# UNITED STATES PATENT AND TRADEMARK OFFICE

APPLICATION NO.	FILING DATE	FIRST NAMED INVENTOR	ATTORNEY DOCKET NO.	CONFIRMATION NO.
10/781,323	02/18/2004	Paul Mantz	AGX-78 (AGXG-7)	9445
22827 7590 01/29/2009 DORITY & MANNING, P.A. POST OFFICE BOX 1449 GREENVILLE, SC 29602-1449				
EXAMINER				
CHIN, PAUL T				
ART UNIT		PAPER NUMBER		
3652				
MAIL DATE		DELIVERY MODE		
01/29/2009		PAPER

### Office Action Summary

**DETAILED ACTION**

Exhibit A

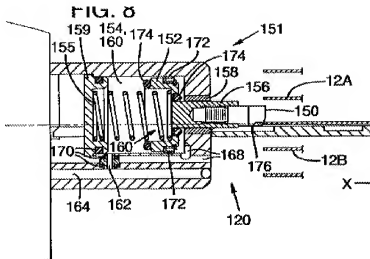
Applicant basically argues that "a spring of Bacchi et al. is to extend an active contact point and vacuum pressure to retract the active contact point".

The argument is not persuasive. For instance, claim 1 recites "a biasing member biasing the piston towards a retracted position". Exhibit A teaches an inner piston (159), another piston (152), a pushing device (150), and a spring 155 capable of pushing against the piston 159 towards a retracted position.
